Amendment

/16 NO.1 TRITON SQUARE

246868-A_A-XX-XX-DR-AX-30510 North Elevation

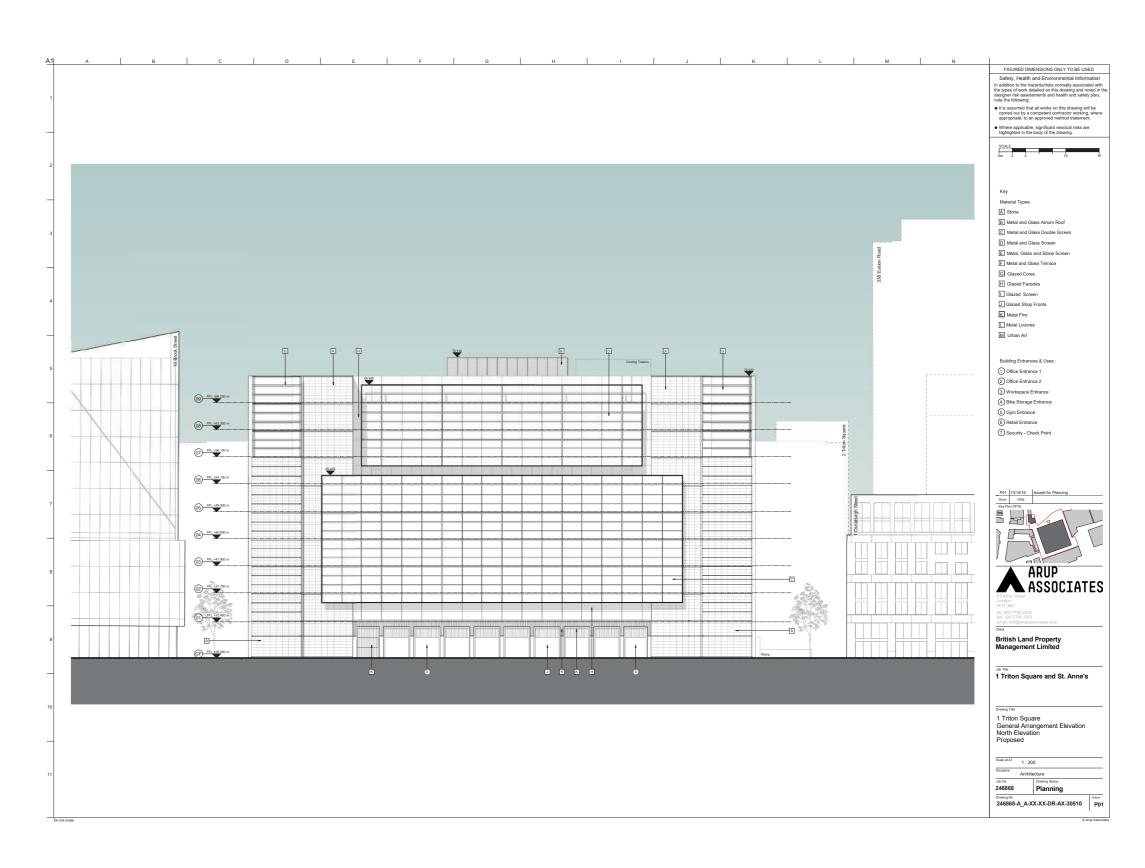
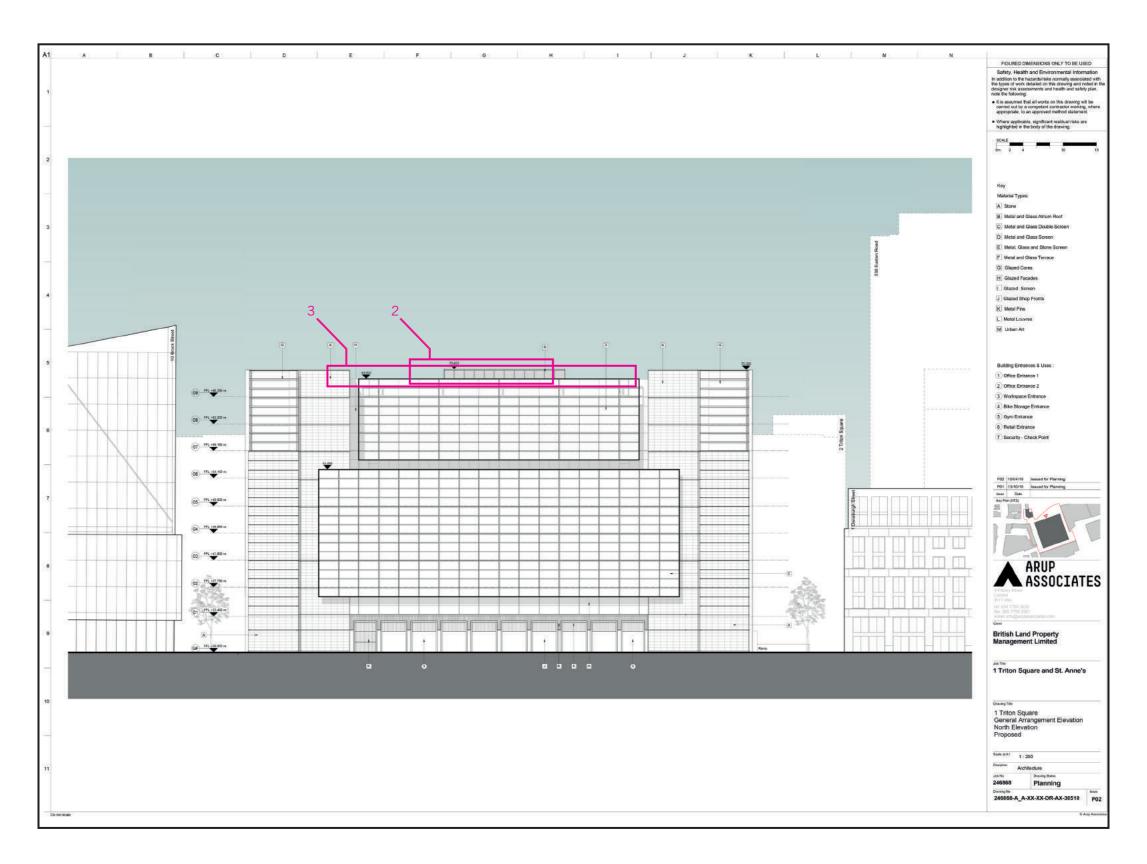
- (2) Atrium roof height reduced by one storey from 73.1 to 70.4 AOD.
- (3) Plant screen design adjusted The facade that extends past roof level now to include fritted glass as plant screen rather than previous set back. This change is to the main N,S,E & W elevations only and excludes the SE entrance corner of the building.

246868-A_A-XX-XX-DR-AX-30520 East Elevation

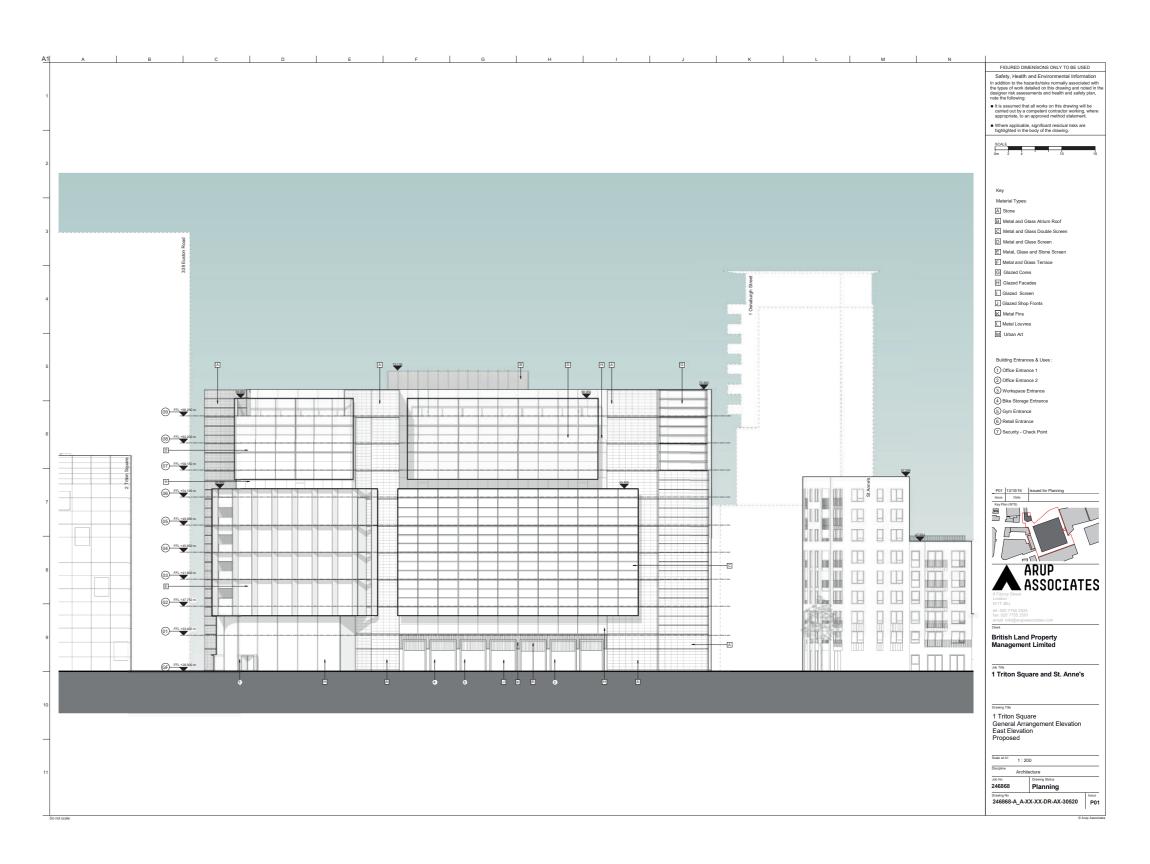
- (2) Atrium roof height reduced by one storey from 73.1 to 70.4 AOD.
- (3) Plant screen design adjusted The facade that extends past roof level now to include fritted glass as plant screen rather than previous set back. This change is to the main N,S,E & W elevations only and excludes the SE entrance corner of the building.
